**TYNAGH ENERGY
L I M I T E D**

Ref: TEL/CJD/15/232

RE: Consultation on Regulated Tariff Calculation Methodology

² DS3 System Services Procurement Design and Emerging Thinking Decision Paper SEM-14-108

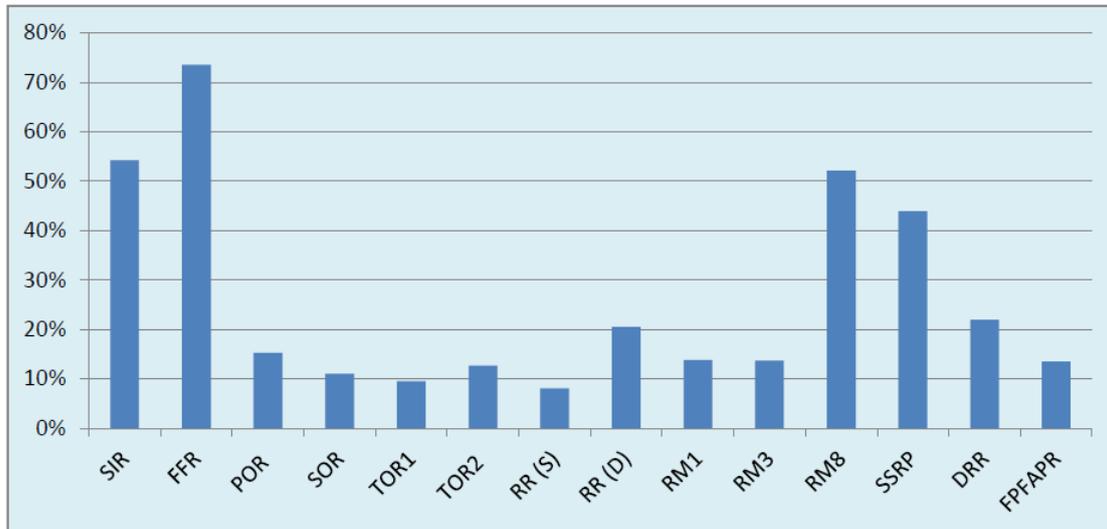
No. To increase SIR would require a reduction in minimum generation. This reduction in minimum generation will not provide any other reserve service (though it may provide some increase in ramping margin).

Therefore the cost of this reduced minimum generation will need to be paid for from SIR revenue. The following chart from the decision paper ²illustrates the estimated shortfall in each of the services. The 54% shortage in SIR is noteworthy.

In the analysis of SIR on page 28 of the Procurement consultation³ the SEMC notes that this service will largely be provided by existing conventional units. Therefore the cost of providing for this significant shortage of SIR will need to be provided by enhancements to existing conventional units. The units that reduce their minimum generation will not benefit from any other revenue stream (i.e. Energy or Capacity Revenue), in fact due to their lower minimum generation they may lose Energy Revenue during off peak times.

We do not agree. The Pöyry paper states that in the event that greater volumes of SSRP are required while the Decision suggests (see the chart in the previous page) that there will be a requirement for a 40% increase by 2020. The whole basis for the tariff for this service is that it is unlikely that there will be a change in requirement.
